PROJECT NAME: COMMERCIAL LOT NEW OFFICE

PROJECT NUMBER: 2024080065

APPLICATION: MINOR SITE PLAN #31909

A200

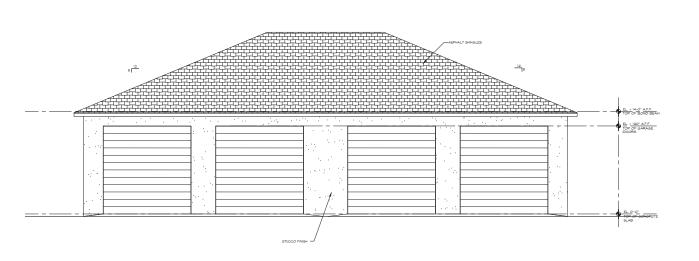
REMARKS: Sheet A200 still has Units A & B that need to be corrected to Units 1 & 2.
